## 2. Assessment and Advice

### 2.1 AUSTRALIA PACIFIC LNG (APLNG)

### 2.1.2 Summary of Assessment

**Figure 2.1-2.** Location of natural groundwater discharge sites (springs) with respect to coal seam gas tenements considered in the current assessment.

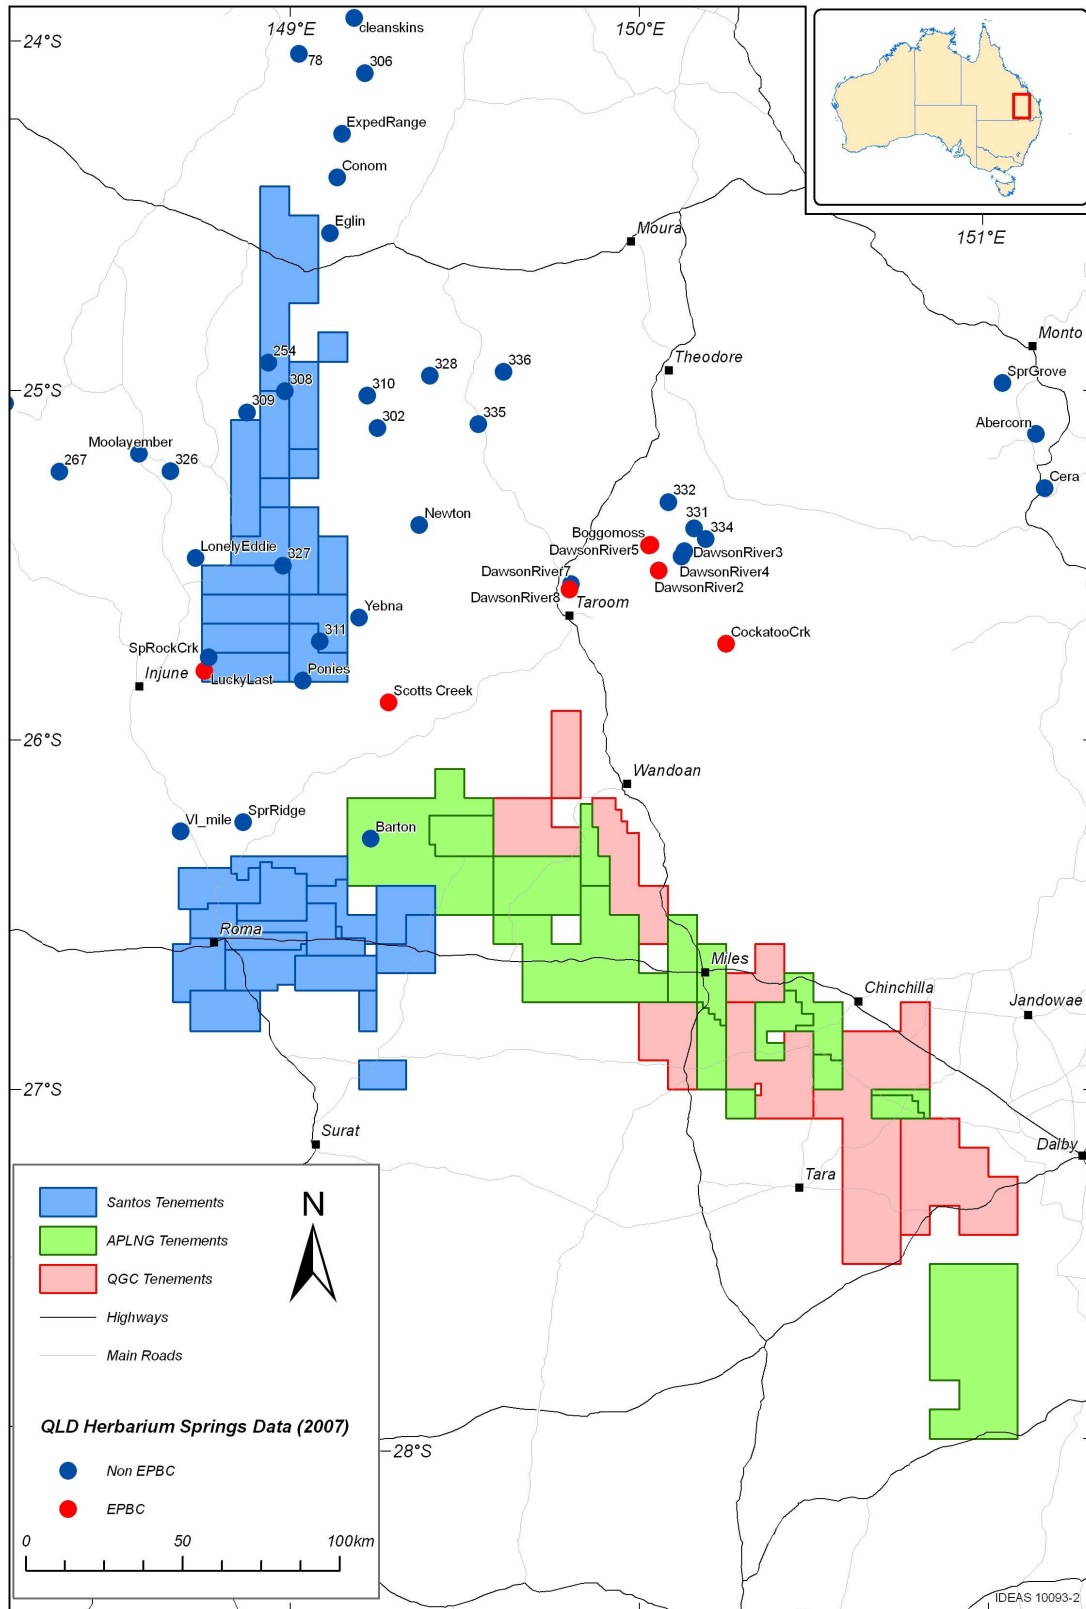
Only one registered “recharge” spring was identified within APLNG leases, in the western corner of the Pine Hills development area (Fig. 2.1-2). The spring is included on the Qld GAB WRP Springs Register and the Qld Herbarium database, but does not appear in the DEWHA mapping of Threatened Ecological Community - The Community of Native Species Dependent on Natural Discharge of Groundwater from the Great Artesian Basins. The spring is listed as ‘RJF Site No NV333’ and classified as active but not visited. APLNG hydrogeologists visited the site in July 2010 and reported no surface hydrological expression or vegetation indicative of a spring or GDE. The feature was reported as a possible seepage relating to an incised erosional feature at base of deep soil profile after significant rainfall (APLNG response to Geoscience Australia questions – 23 August 2010, p. 29).

APLNG identify numerous high value “recharge” and “discharge” spring complexes associated with the Hutton Sandstone and Precipice Sandstone units. These are located proximal to the Taroom and Injune townships, at least 50 km north and north-west of the northernmost APLNG development areas (DNR 2005). The “discharge” spring complexes located near Taroom are supplied by artesian flow from the Precipice Sandstone, rising to the surface through joints and fractures in that unit. These complexes are known locally as 'boggomosses', and provide a wetland habitat in an area that experiences prolonged below average rainfall conditions (DEWHA 2001) (APLNG Vol. 2, Ch. 10, p. 17).

APLNG have already adopted the recommendation put forward by their consultant (Hydrobiology – APLNG Vol. 5, Attach. 17, p. 126) that they undertake field investigations to confirm the classification and condition (as well as location, type, source aquifer) of springs north of Roma (Six Mile, Spring Ridge). In addition, we recommend that APLNG undertake investigations of the springs east of Taroom (Cockatoo Creek) in order to inform a revised route for the pipeline. Despite being outside the APLNG tenements and modelled range of drawdown, it would also be pertinent to assess the spring (Scott's Creek) north of the Pine Hill's development. This site is known to host EPBC significant communities and to account for any variation in the modelling results which may alter the extent of drawdown influence it is recommended that this site be fully characterised for baseline purposes.

Figure 2.2-2. Location of natural groundwater discharge sites (springs) with respect to coal seam gas tenements considered in the current assessment.

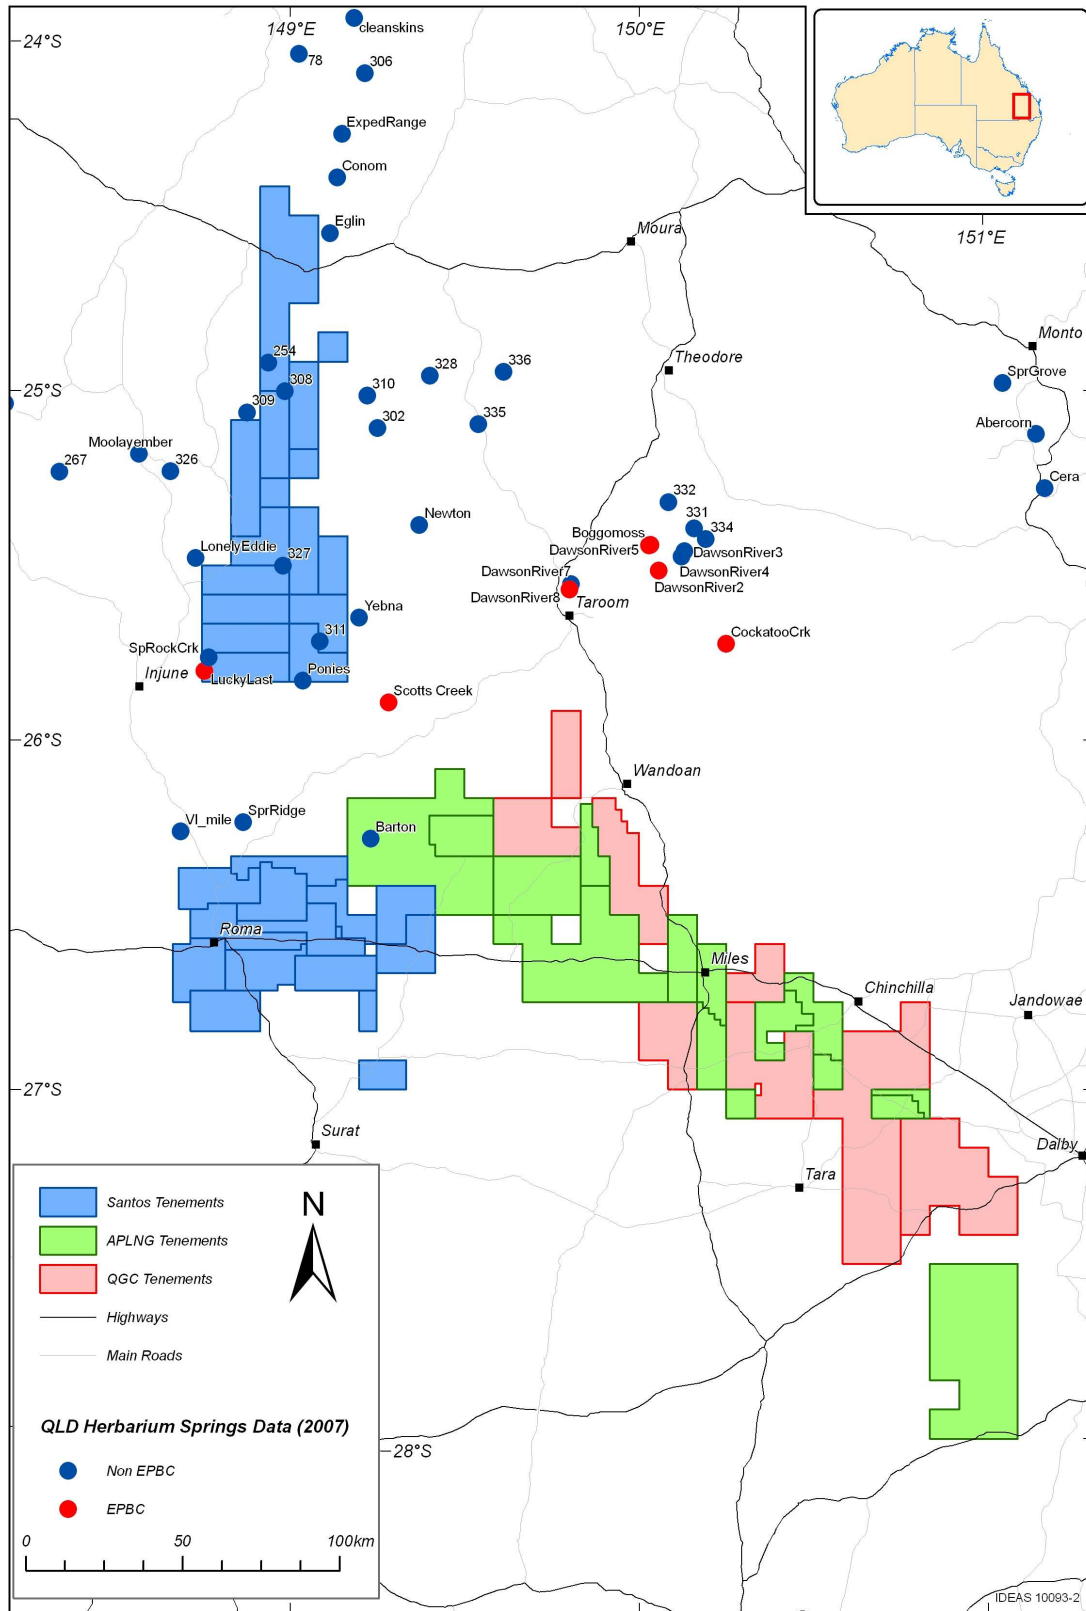
QGC provide little information in their main EIS documents regarding the assessment, monitoring and mitigation of potential impacts of groundwater extraction on the EPBC Act listed endangered ecological community 'The community of native species dependent on natural discharge of groundwater from the Great Artesian Basin'. Initial assessment of an insignificant impact is the stated reason for this information not being considered in their final reporting (QGC Response to Geoscience Australia initial Assessment – 13 August 2010, p. 10), owing largely to the absence of any listed springs within or in close proximity to their tenements. Based on a review of the Queensland Herbarium Springs of Queensland Dataset (Version 4.0), QGC identify and report that no "discharge" springs or EPBC Act threatened communities of 'native species dependent on the Great Artesian Basin' occur within the study area (QGC Vol. 3, Ch. 8, p. 5).

GA and s. 47F(1) also identify no EPBC listed communities within the QGC tenements or within the QGC modelled zone of depressurisation. Some springs (type unspecified) are noted by QGC within 30 to 50 km of the CSG project area. At 30 to 50 km from the CSG fields QGC predict that drawdown in the Springbok Sandstone aquifer (Injune Creek Group), Hutton Sandstone and Precipice Sandstone aquifers will be negligible (QGC App. 3.4, Rep. 7, p. 72).

QGC have committed to surveying and re-assessing springs within their tenements and within a 30 km radius of their proposed development areas (QGC Response to DEWHA 300810 – Attach. 1 – Springs Monitoring).

Figure 8. Area of > 5m drawdown of the water table predicted by APLNG (APLNG, 2010, Vol 5 att 21).

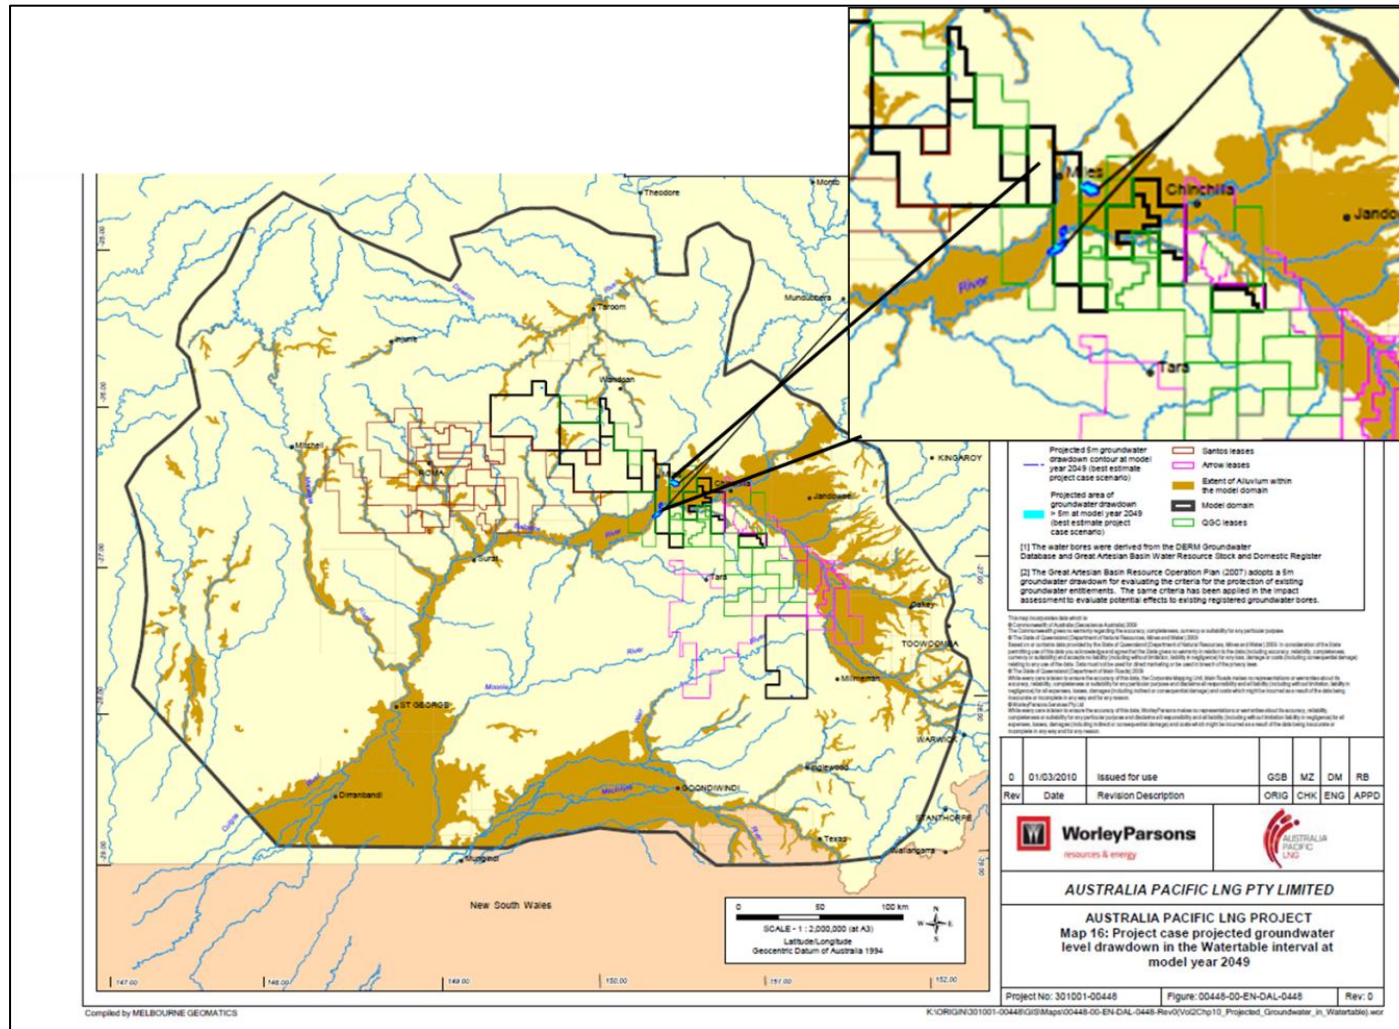
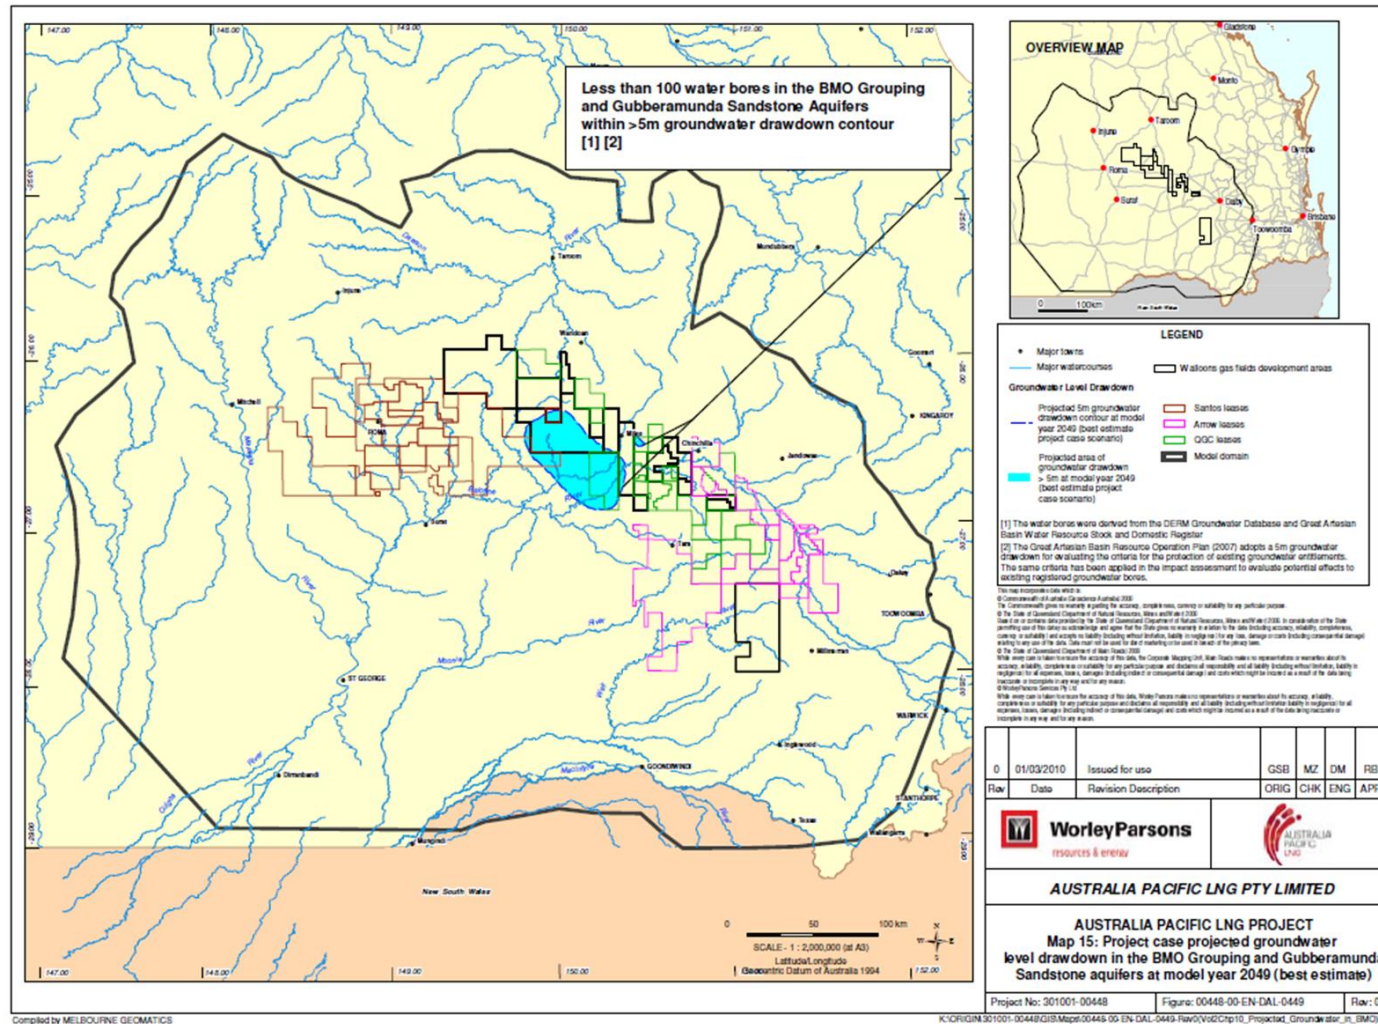
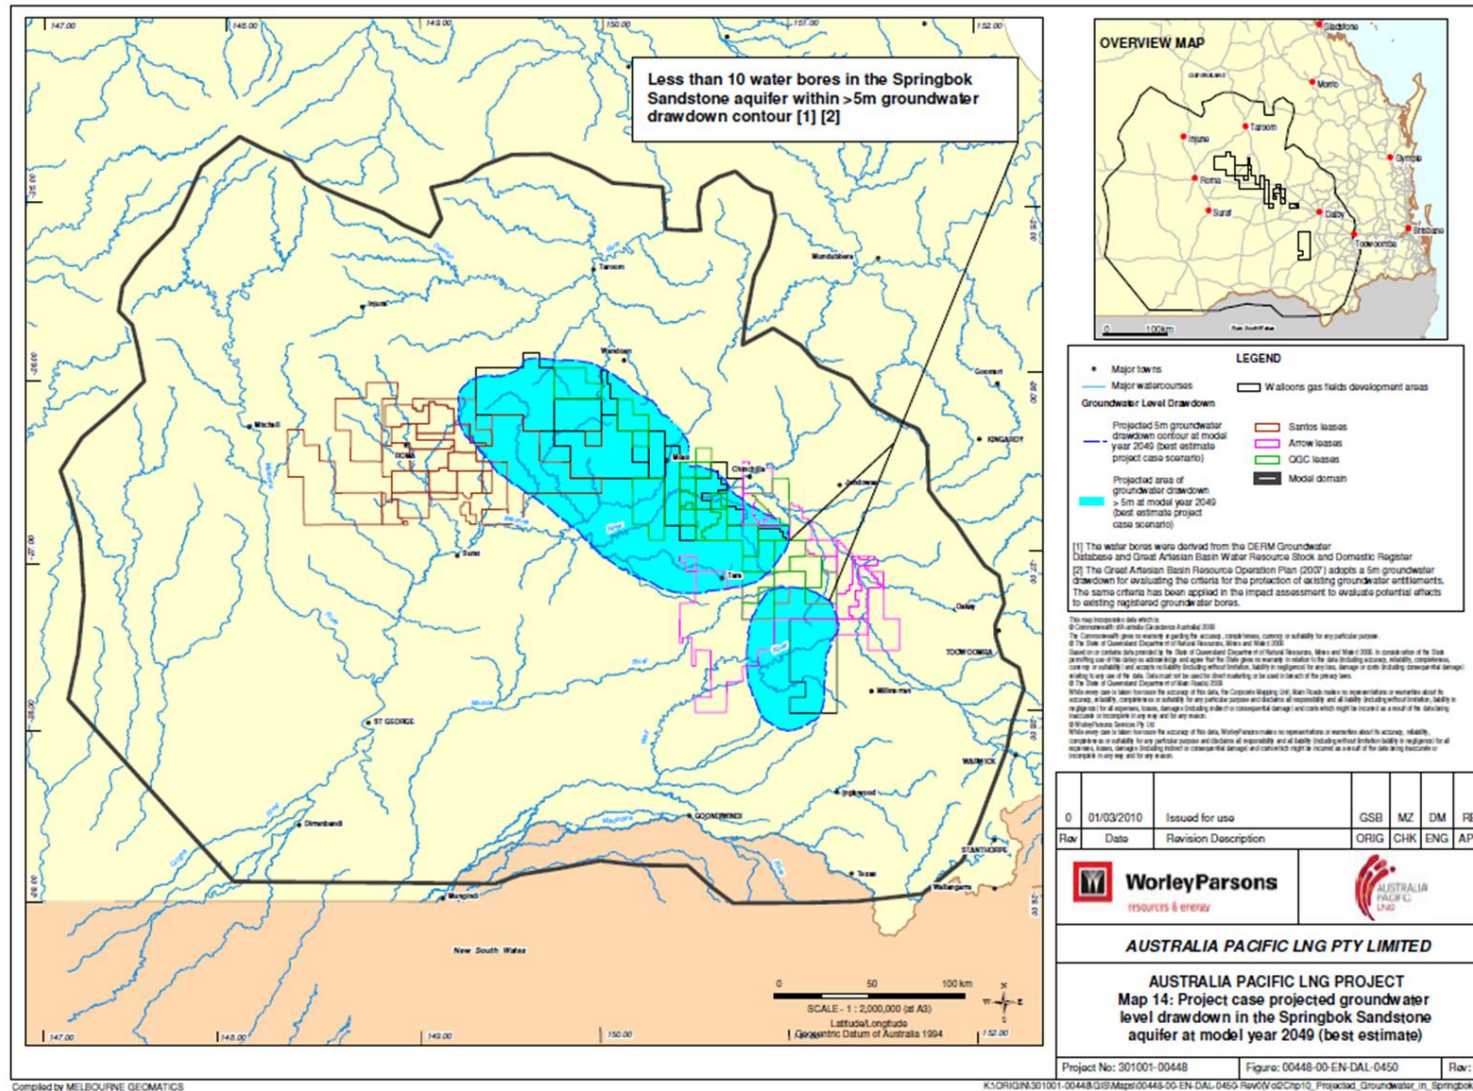
only, maximum average drawdown occurred in 2049 with average watertable drawdown estimated to be less than 2 m with localised areas of higher drawdown (APLNG, 2010, Vol 5 att 21). Drawdown between 5 – 7 m was predicted to occur in two small areas. These areas are located immediately downstream of the Chinchilla Weir and in an area on the margin of the alluvium just south of Miles (Figure 8). Higher drawdown was coincident with the area of greater predicted drawdown of the underlying Gubberamunda and Springbok aquifers (Figure 9, Figure 10) and where the confining layer was thin or absent (APLNG, 2010, Vol 5 att 21). APLNG (2010) suggest that operation of the weir may compensate for the expected decrease in baseflow in the Condamine River due to drawdown of the water table in the area downstream of the Chinchilla Weir. It should be noted that groundwater use downstream of the Chinchilla Weir is low.

It should be noted that only one water bore was identified in the area where drawdown of the water table was predicted to be greater than 5 m by APLNG (2010). However, a significantly greater number of bores are located along the western margin of the Condamine Alluvium (the Eastern extent of CSG development, Figure 1). Further work is required to predict magnitude and spatial and temporal extent of drawdown along the western margin of the Central Condamine Alluvium.
